March 17, 2010

**Re: North Bala Falls Small Hydro Project – Response to Elevation Request Dated
November 27, 2009**

Figure 6.5
 Swift River Energy Ltd.
 North Bala Small Hydro Project
Areas Restricted During Operation

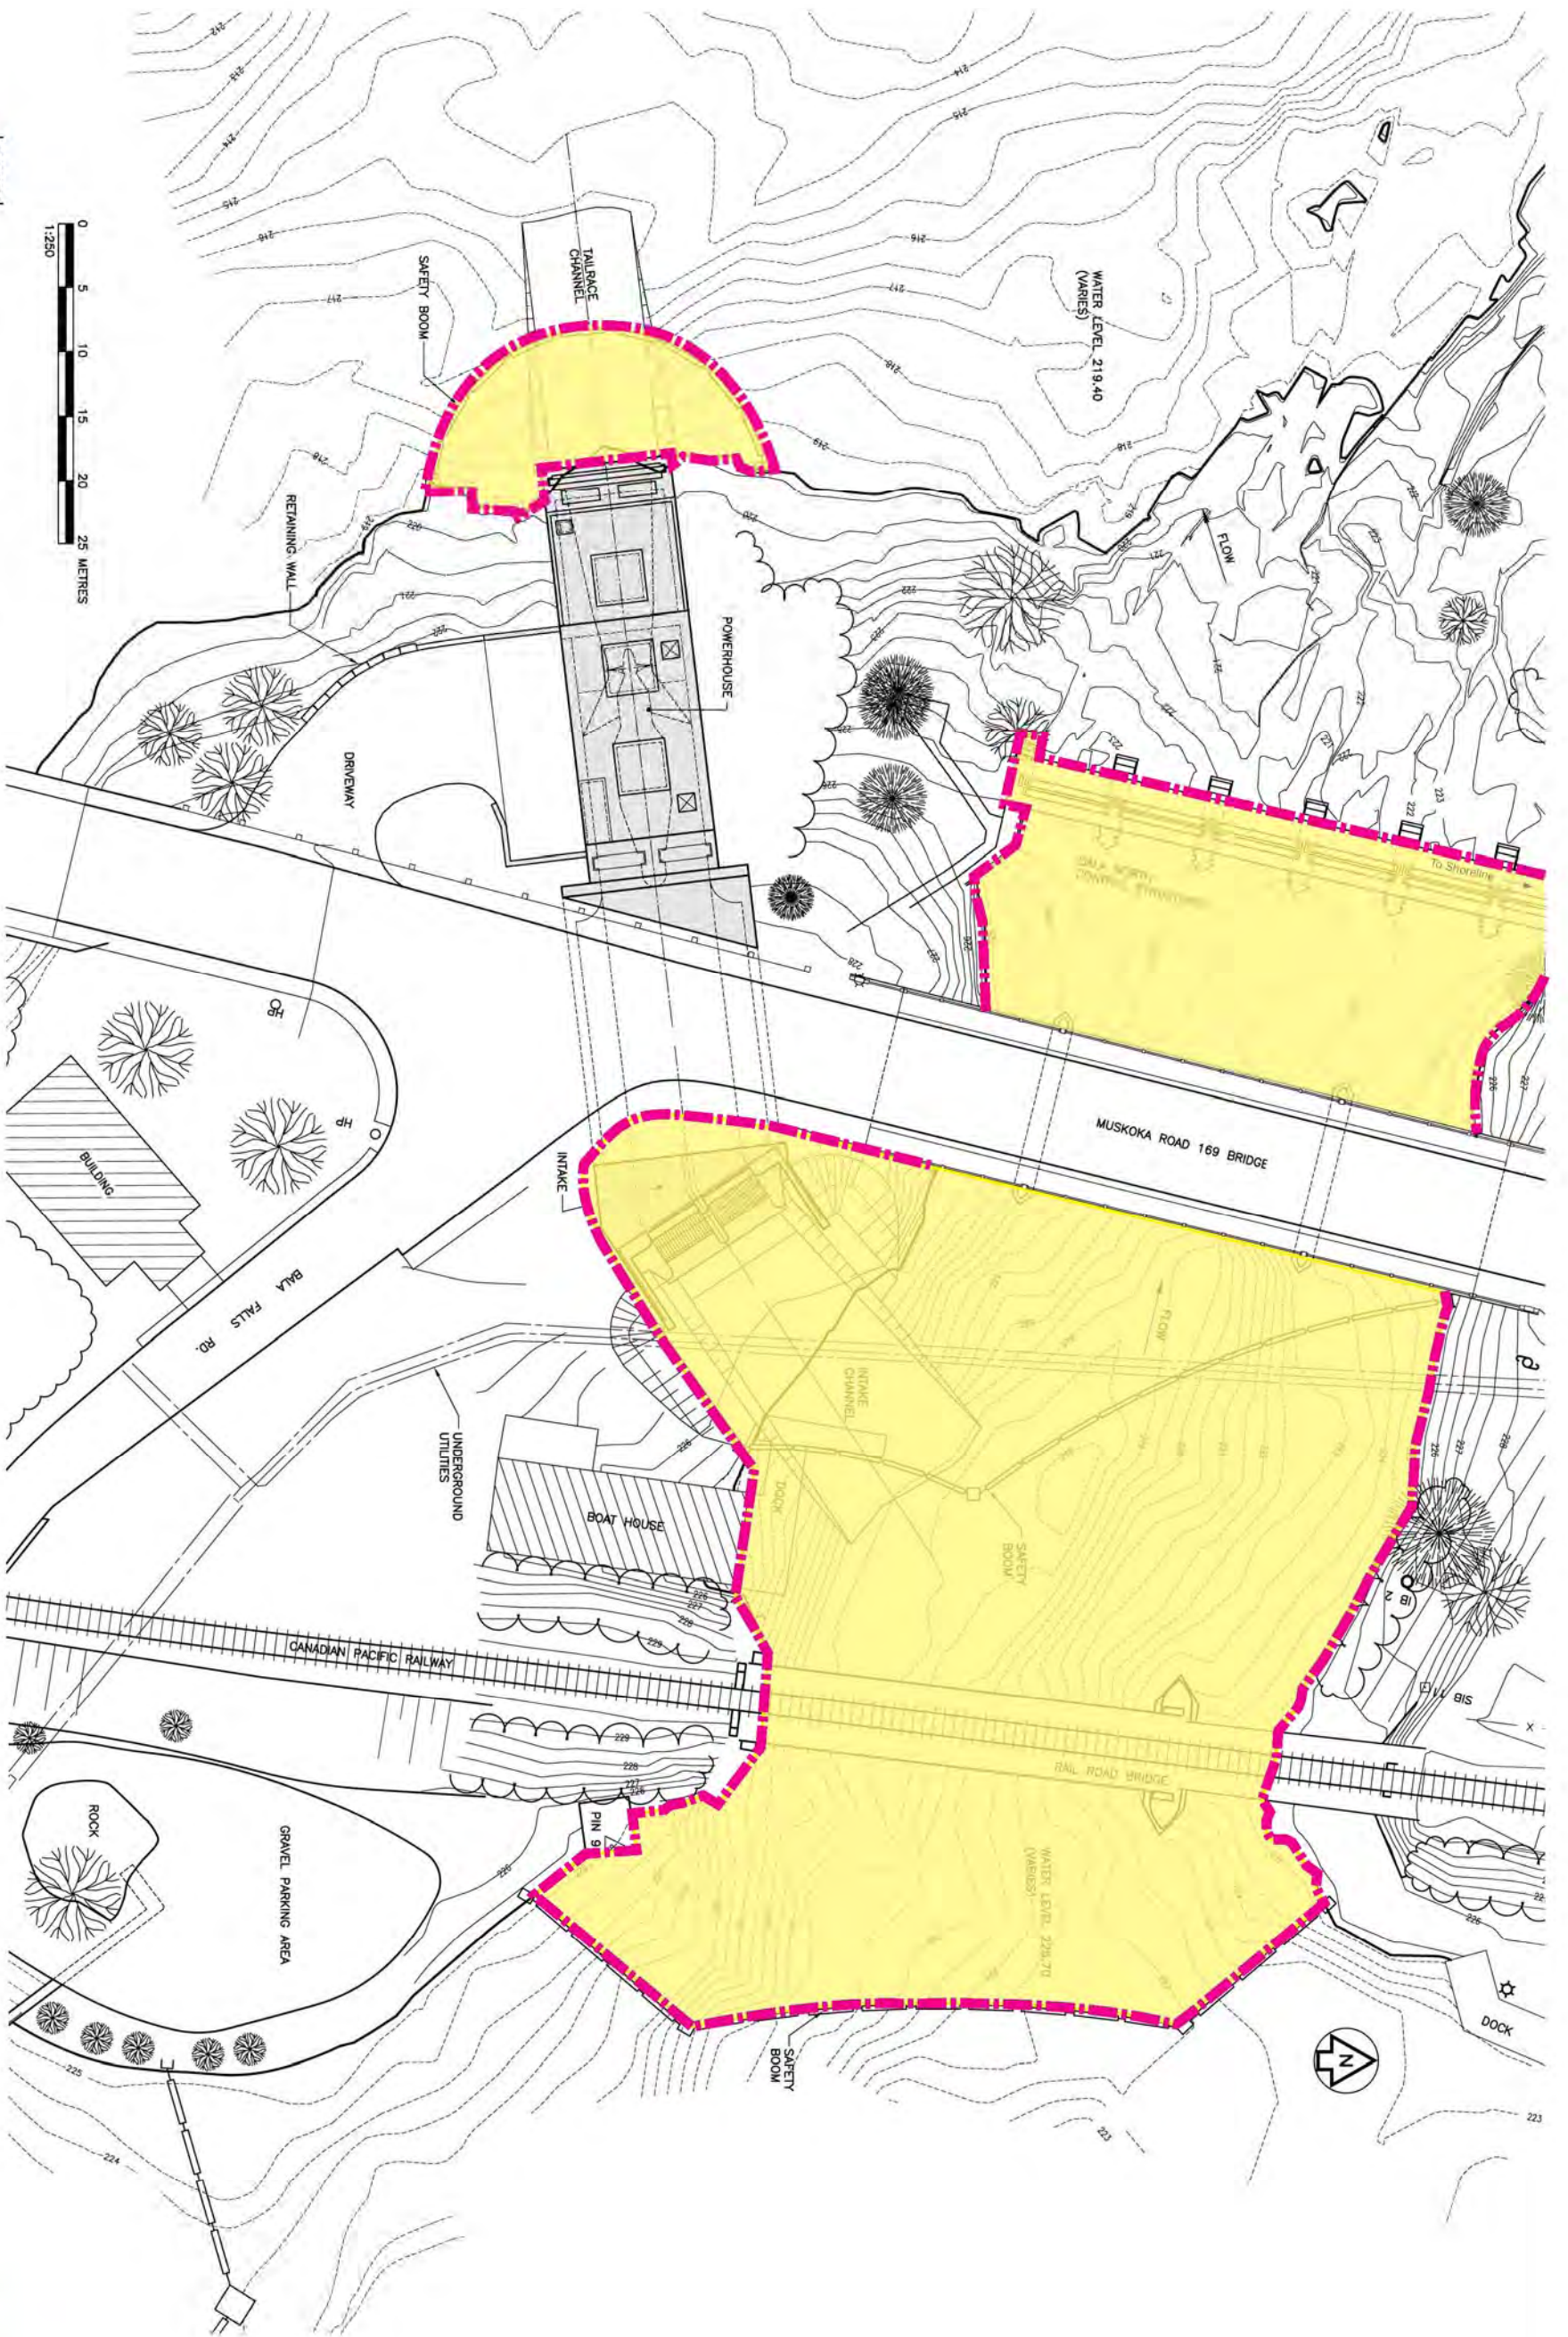
- k. Clarification is required regarding the ability of the public to access the north shore of the North Falls. Will currents from the tailrace prohibit swimming in the area?*

- l. Confirmation is required that public will have access to the south bank of the North Channel.*

- n. Section 6.3.6.1 indicates that access to the water in the area of the works will be discontinued. Clarification is requested as to how this restriction will be done.*

- p. SREL is requested to identify any restrictions or warnings that may be imposed on divers in and around the works.*

As illustrated on the attached figure 6.5 from the ESR, there will be no restricted access to the north shore of the North Falls, downstream of the dam. TC’s attached letter also states that while velocity at the outfall will increase from 0.6 to 1.3 m/s, overall velocities will be reduced from 2.4 to 1.3 m/s. It also states that velocities will quickly dissipate to negligible. Therefore, velocities will not be significantly affected on the north shore.

As the attached Figure 6.5 from the ESR illustrates, there will be no restricted areas along the south bank of the North Channel, downstream of the North Dam. SREL is also proposing to construct a new set of stairs down this incline to facilitate access.

The attached Figure 6.5 clearly outlines the restricted area during the operations phase of the project. The water side of the tailrace restricted area will be enclosed by a floating safety boom and the land side will be blocked with a combination of landscaping features (vegetation and rocks) as well as architecturally designed handrail systems that meet the Ontario Building Code to keep children from falling through or people climbing on.

Divers will no longer be able to dive in the area shown in yellow on the attached Figure 6.5.

There would be a small restricted area within the tailrace boom downstream of the plant as shown on Figure 6.5. It is assumed that divers generally use the deeper areas downstream of the dams and should, therefore, they should not be significantly impacted by our project.
